## Product Change Notice (PCN)

PCN Number: PCN-0450890R-01

Product(s) Affected: *SJ1-351X-SMT Series* (*SJ1-3513-SMT-TR, SJ1-3514-SMT-TR, SJ1-3515-SMT-TR-BE, SJ1-3515-SMT-TR-GR, SJ1-3515-SMT-TR-PI*)

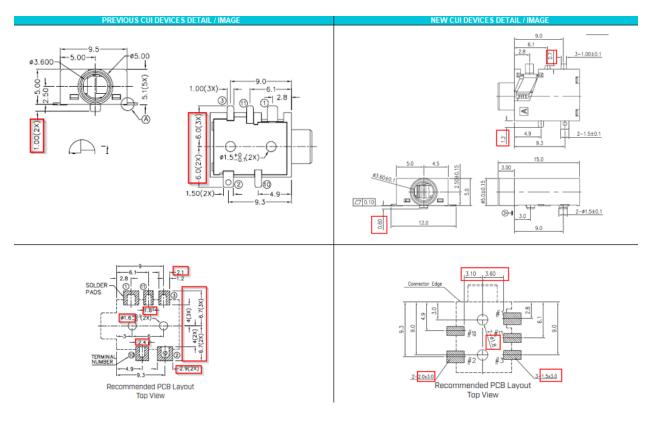
Description of Change: Minor Housing and footprint differences. Material Change on the housing and terminals. See image Below

PREVIOUS CUI DEVICES DETAIL / IMAGE					NEW CUI DEVICES DE	TAIL / IMAGE
	MATER	IAL	PL	_ATING		DESCRIPTION	MATERIAL	PLATING/COLOR
terminal 1	copper	alloy		old flash		terminal 1	phosphor bronze t=0.30	gold flash over nickel
terminal 2		per alloy		old flash		terminal 2	phosphor bronze t=0.20	gold flash over nickel
terminal 3 terminal 10	brass	copper alloy		old flash old flash		terminal 3	phosphor bronze	gold flash over nickel
terminal 11	brass	_	-	old flash		terminal 10	t=0.20 brass t=0.20	gold flash over nickel
plastic	PA10T	_				terminal 11	brass t=0.20	gold flash over nickel
pidotic	FAIDI	_				cover	PA9T (UL94V-O)	see color options
						housing	PA9T (UL94V-O)	see color options
Model No. SJ1	-3513-SMT SJ1-3513C	SMT / S	SJ1-3514-SMT	SJ1-3515-SMT				
Schematic	-3513-SMT SJI-3513C	-SMT S	01 03 03 01 02	SJI-3515-SMT				
Schematic			01 03					
Schematic	sleeve steet		o1 o3 o10 o2 sleeve	sieeve				
Schematic	sleeve sleeve tip		sleeve tip	sleeve tip
